**Subject:** 54th Street Reconstruction and Arden Park Stormwater Management Plan - Updates

## MEMORANDUM

RE: 54th Street Roadway Reconstruction Improvement No. BA-416 - Supplemental Items  
SEH No. EDINA 124747 16.00

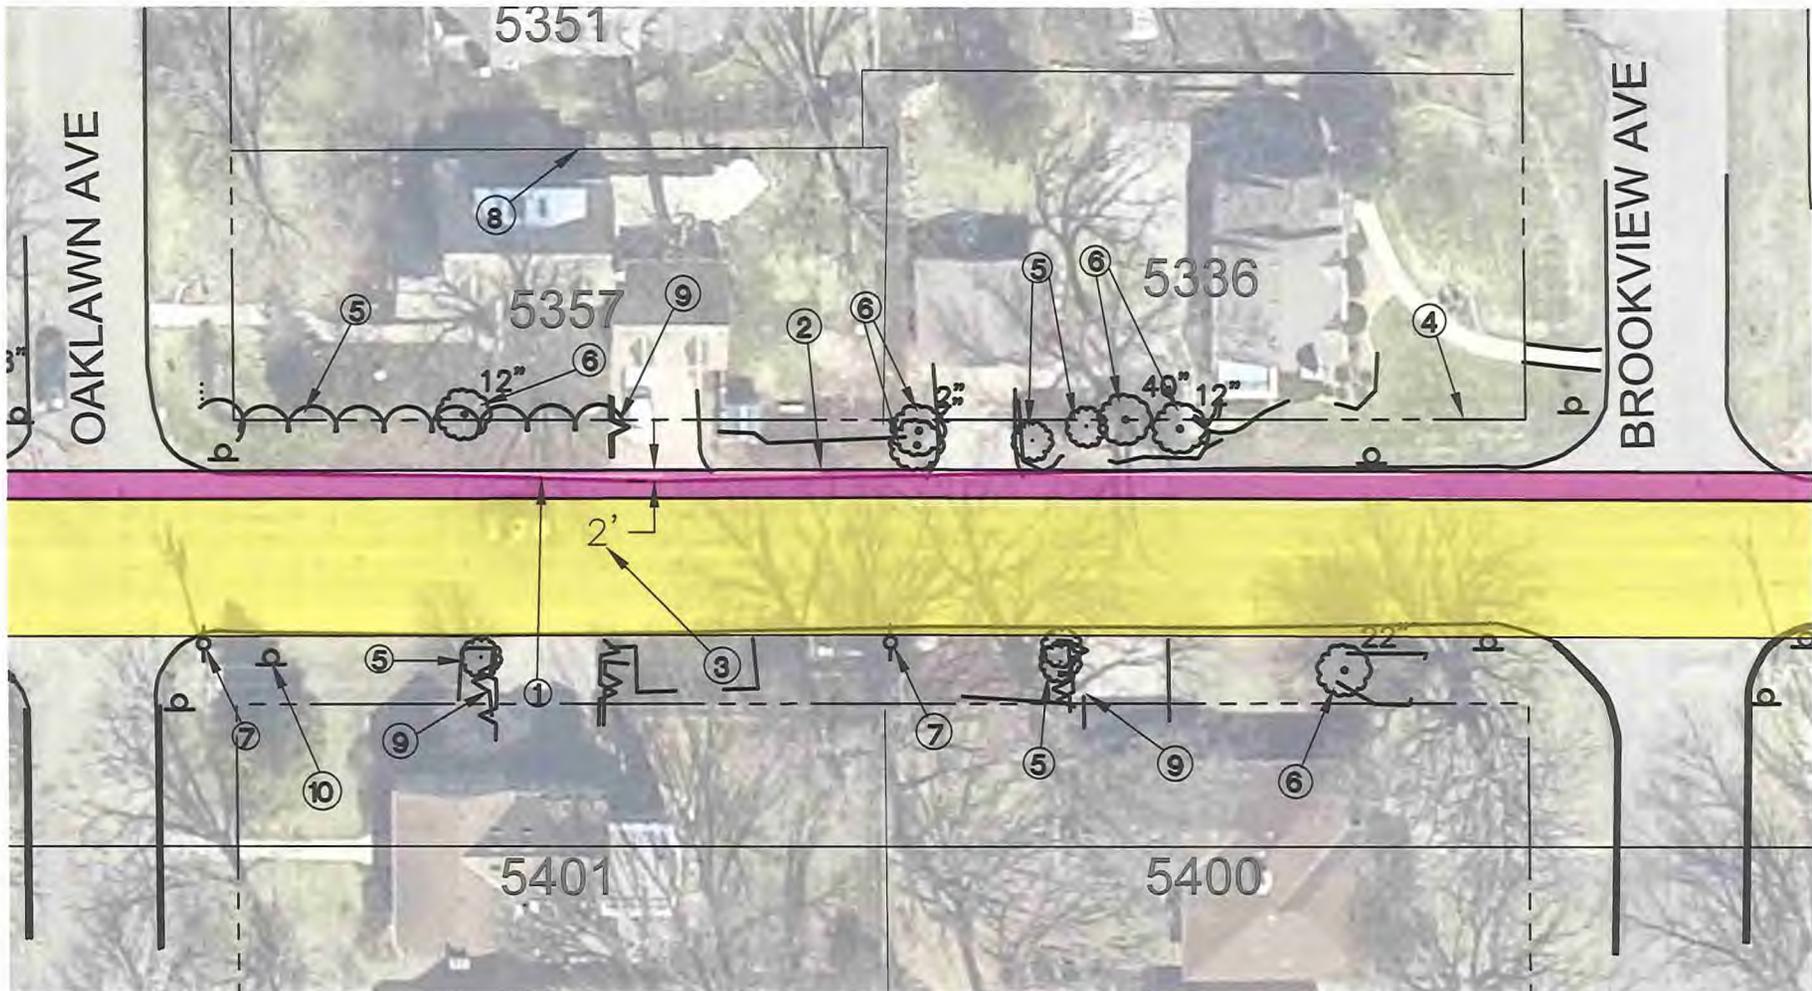
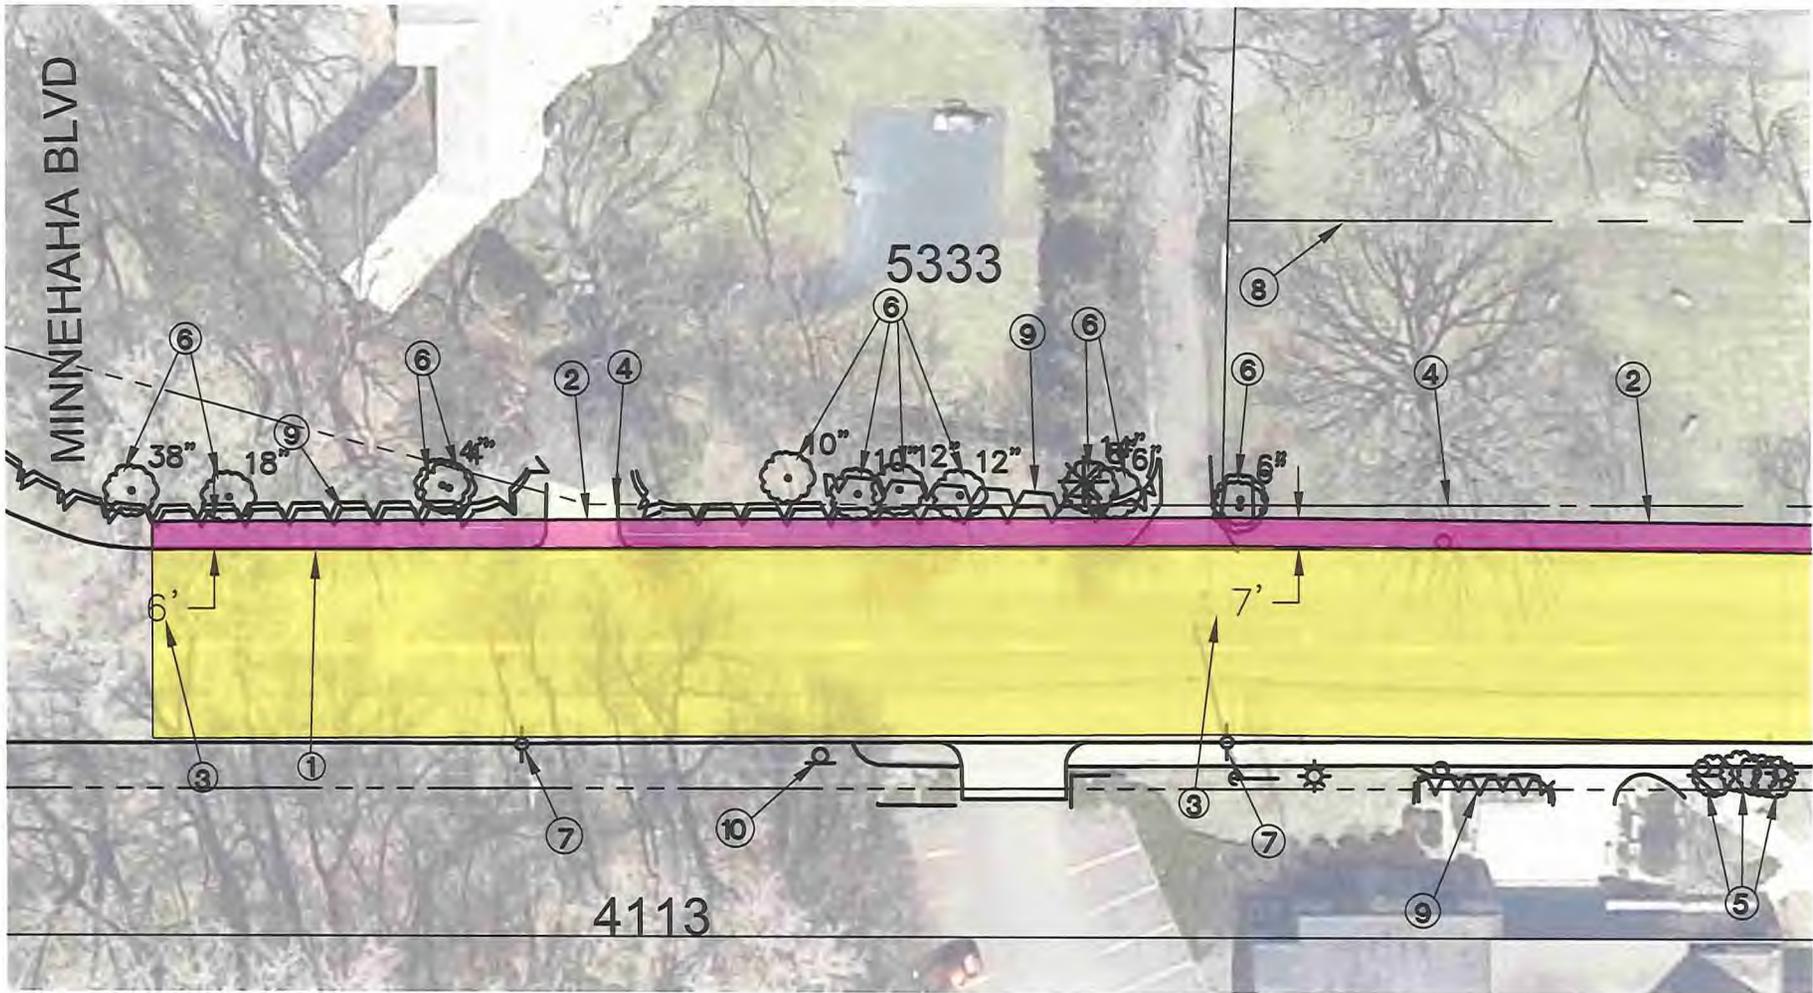
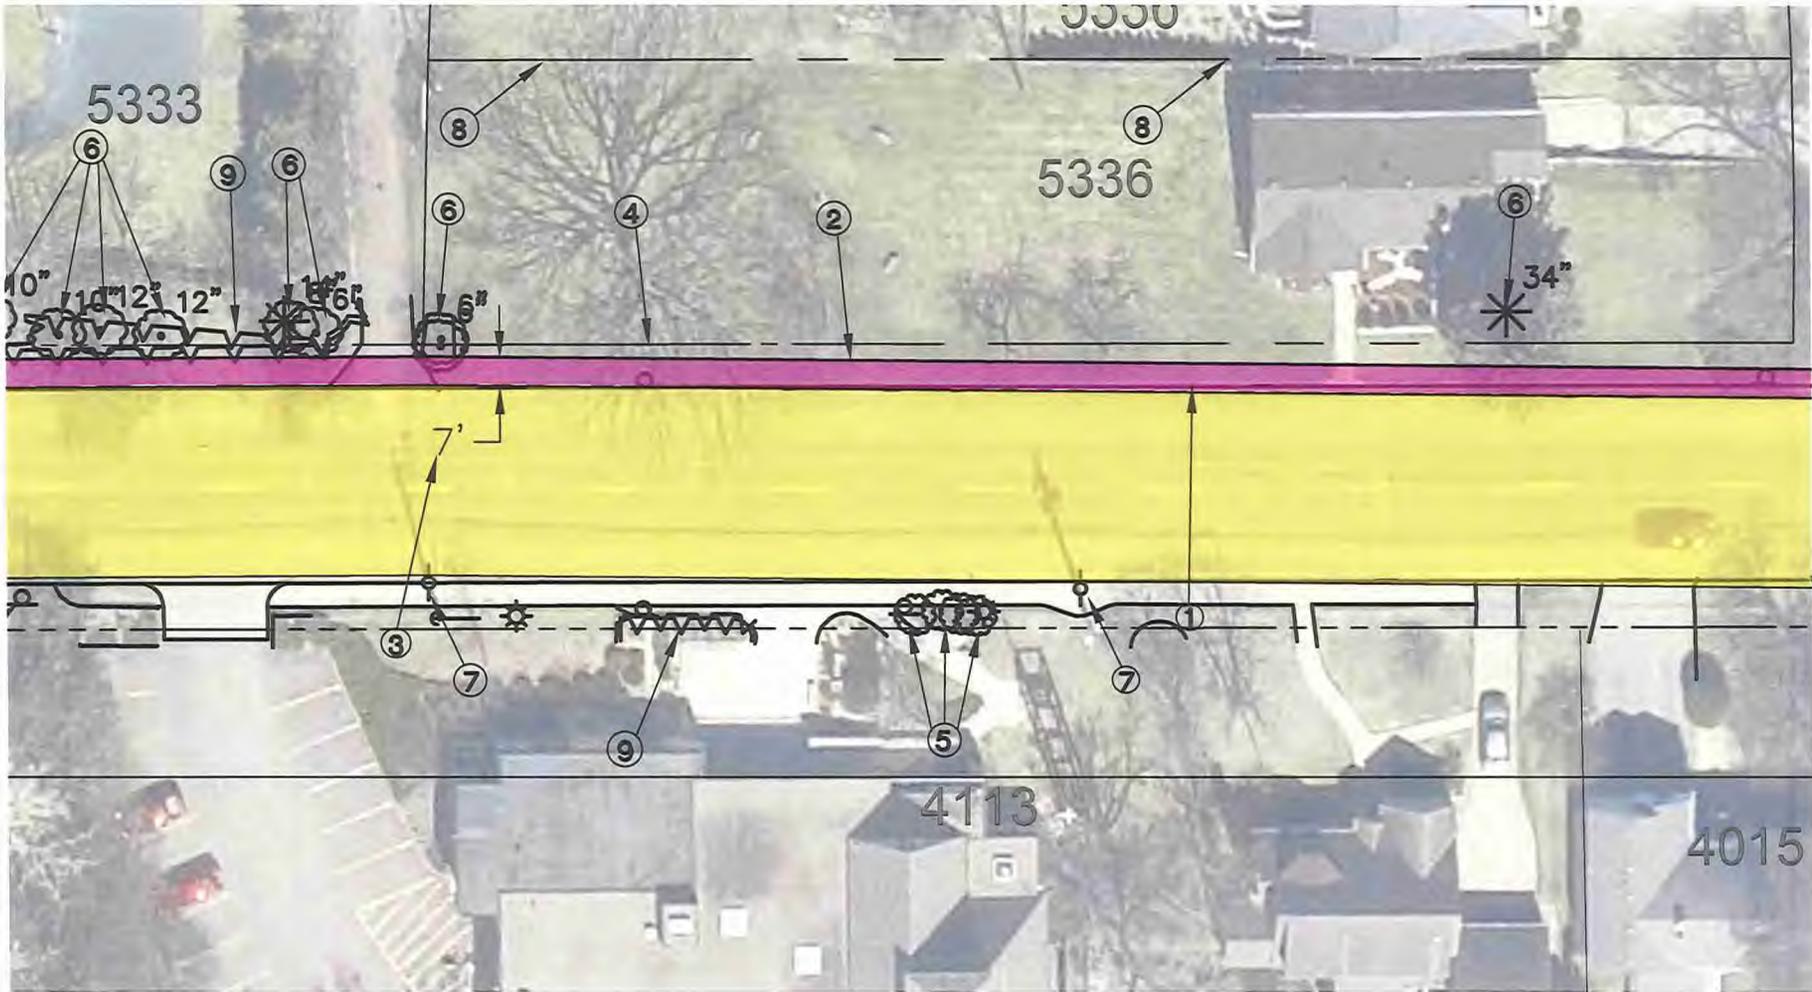
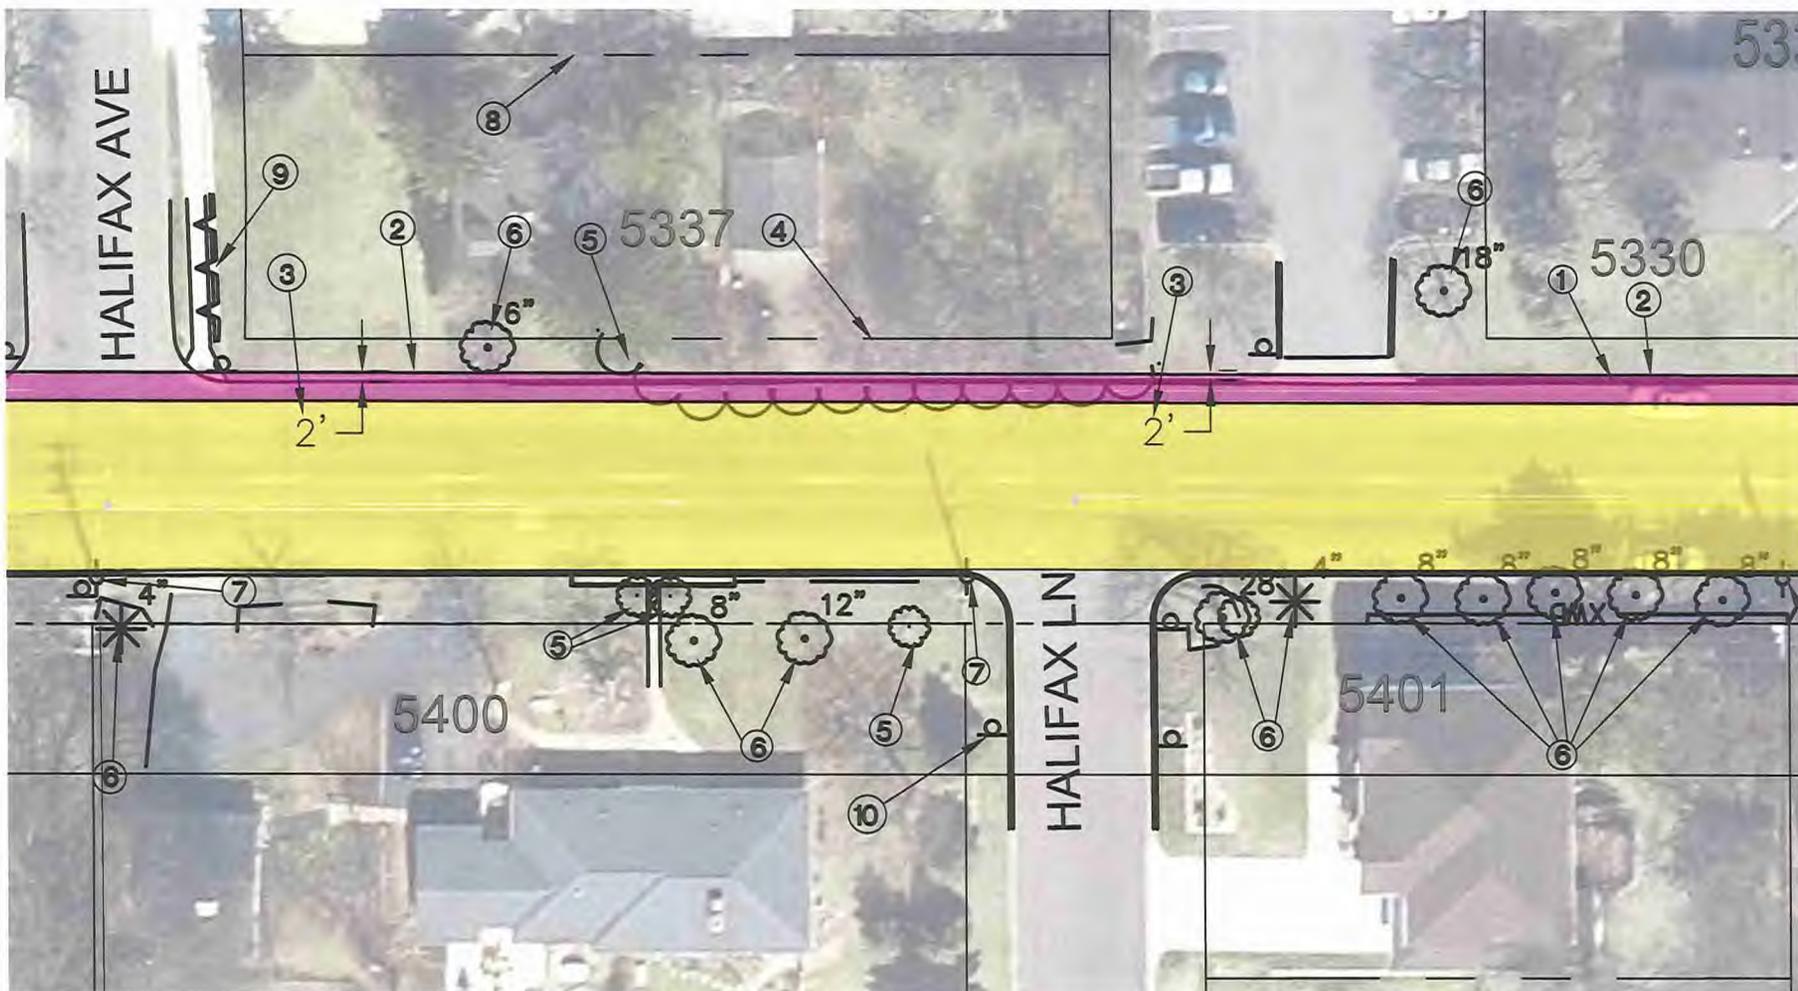
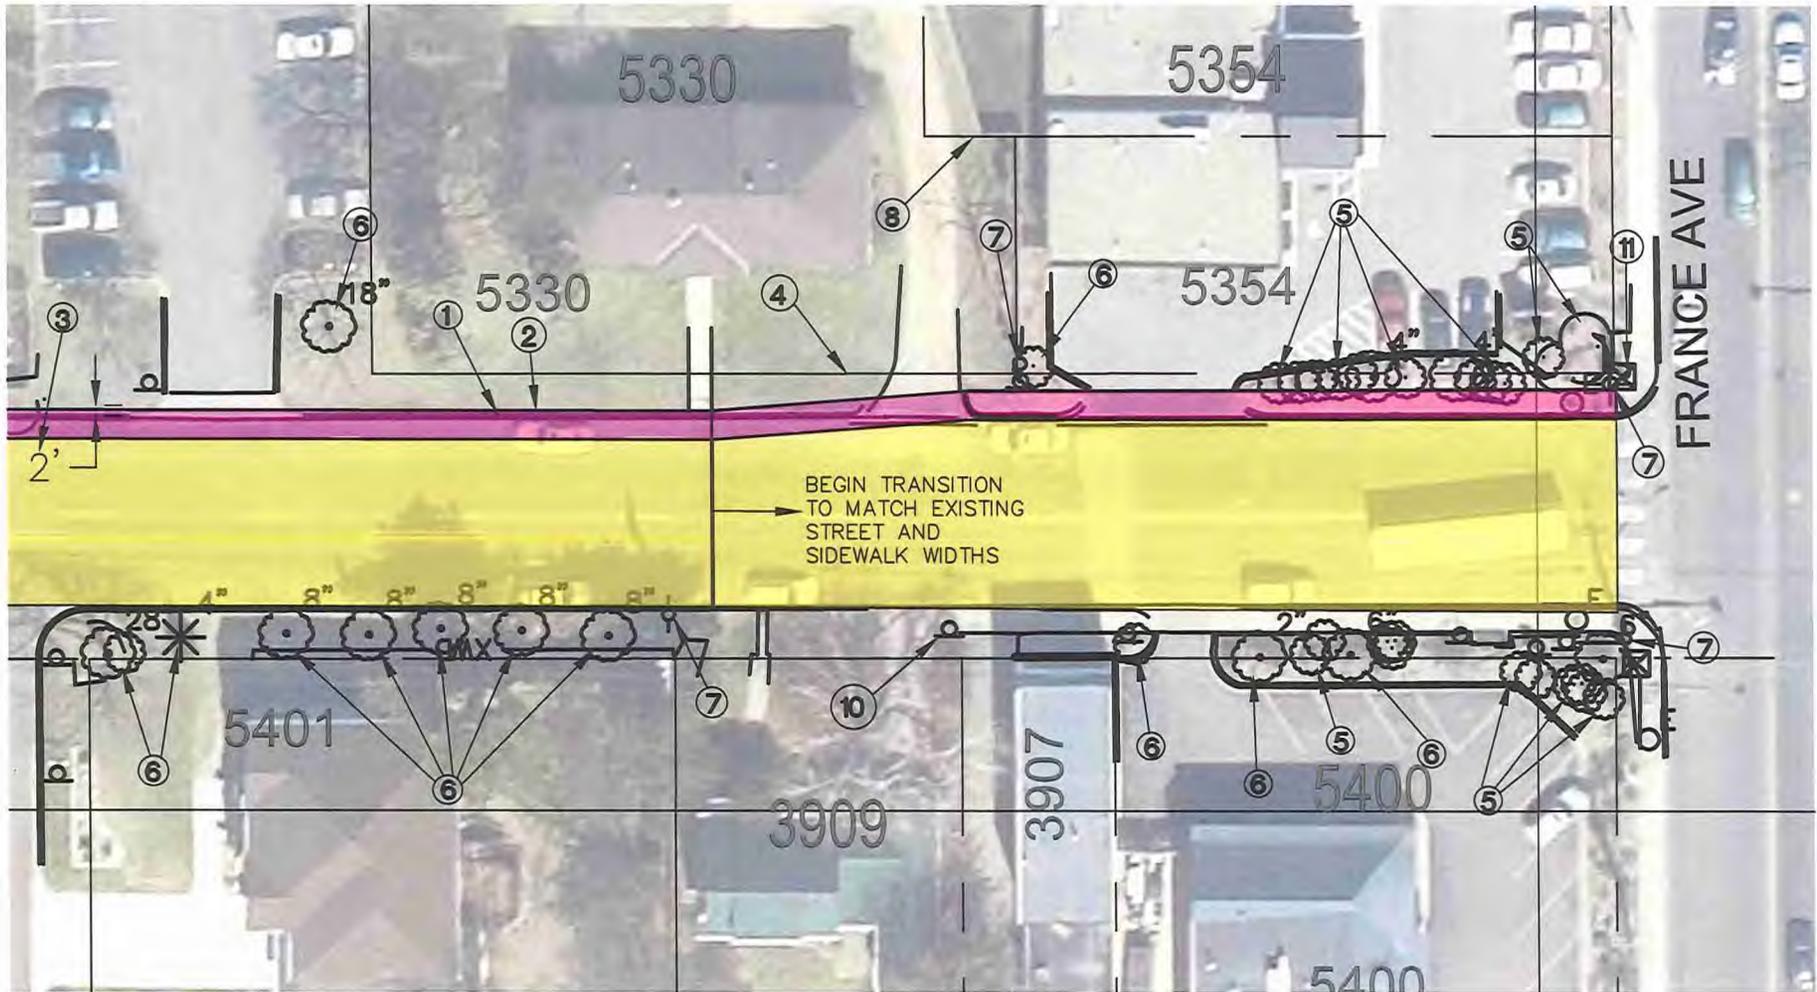
3. Bicycle counts for 2012 and 2013 are attached as Exhibit 3.
4. Metro Transit has approved the removal of bus stops at the Halifax Avenue, Brookview Avenue and Kellogg Avenue intersections.
5. Graphics showing the difference between the north edge of the existing road and north edge of the proposed sidewalk are shown in Exhibit 4.
